**Staff Report for a Single Family Home in the Canemah Historic District
June 19, 2017**

FILE NO.: HR 17-01: Historic Review Board review of construction of a new single family residence in the Canemah National Historic District.

REQUEST: Construction of a new single family dwelling in the Canemah Historic District.

RECOMMENDATION: Approval with Conditions

SHEET #
A2.1
ELEVATIONS

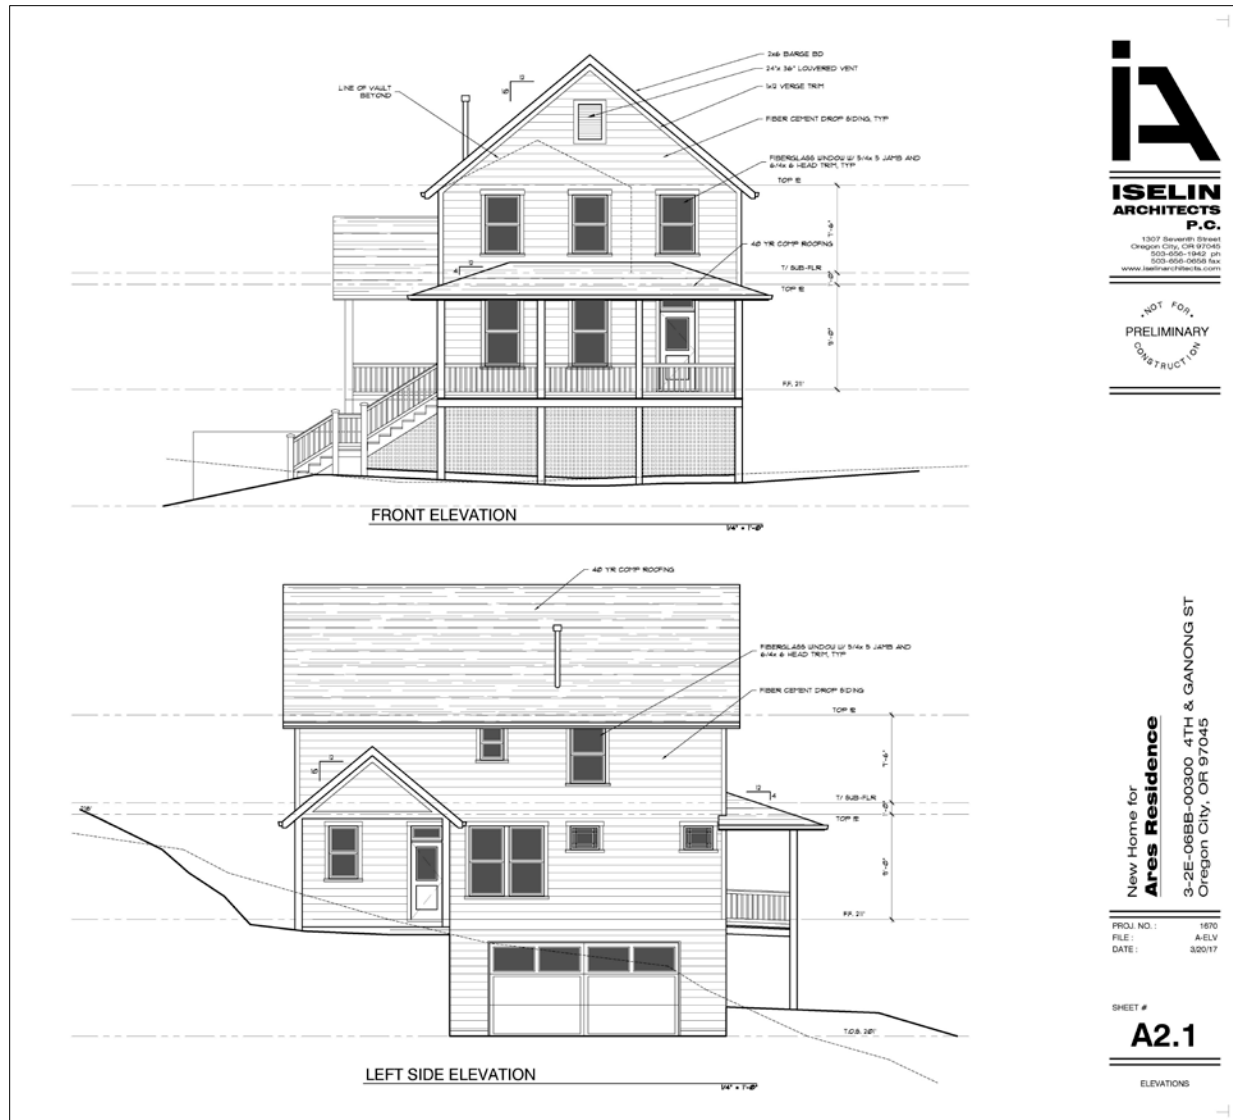
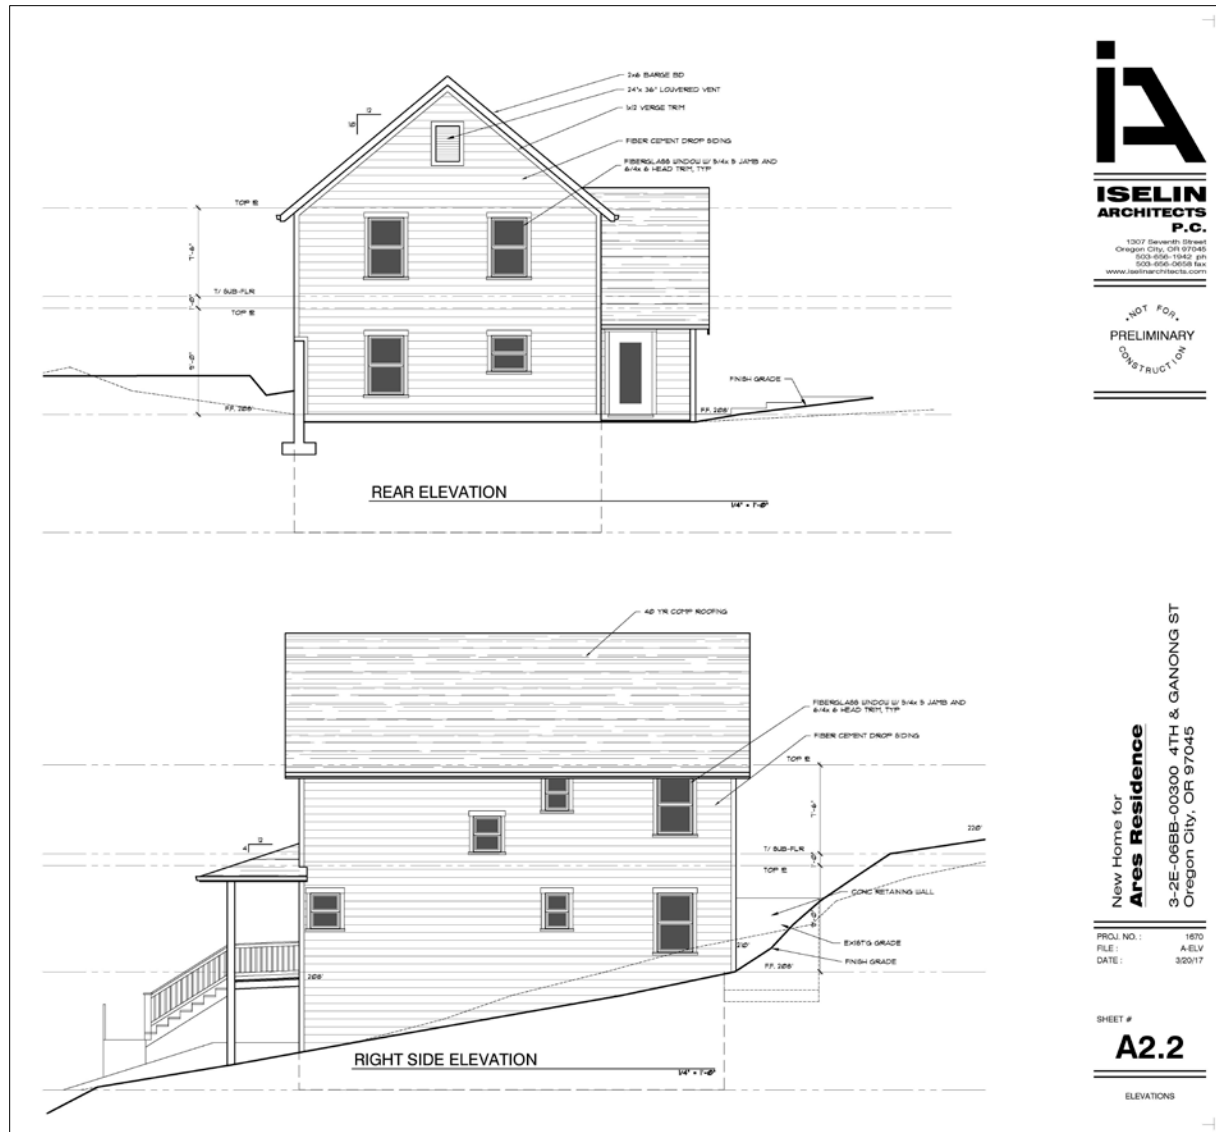
In the elevation drawing provided by the applicant there is significant basement massing on the north and west side of the proposed home.

Staff has identified massing along the north and east side of the proposed home. The home has been set back approximately 20 feet from the adjacent right-of-way to help mitigate for the massing along the right-of-way. The applicant should incorporate landscaping into the design of the home to help reduce the impact of the new home on the surrounding neighborhood. The applicant shall address the massing on the front and east side of the home, incorporating the existing vegetation would help to mitigate for the impacts of the proposed massing on the surrounding neighborhood. To mitigate for the massing in the front of the home one tree (at least 10 feet in height when mature) and four shrubs (at least 3 ½ feet in height when mature) shall be install in front of the home.

- e. Simple vernacular styled lighting.(P)
 - f. Simple paneled fiberglass or wood garage doors with or without windows.(P)
 - g. Cover sections of exposed foundations; Concrete or masonry: exceeding 3½ feet, Piling or posts: 1½ feet; above grade; At slopes measure perpendicular to slope. (P)

There is significant amount of vegetation located on the subject site, and the applicant has indicated on their site plan which of the existing vegetation will be removed and what vegetation will remain. The applicant shall address the massing on the front and east side of the home, incorporating the existing vegetation would help to mitigate for the impacts of the proposed massing on the surrounding neighborhood. To mitigate for the massing in the front of the home one tree (at least 10 feet in height when mature) and four shrubs (at least 3 ½ feet in height when mature) shall be install in front of the home.
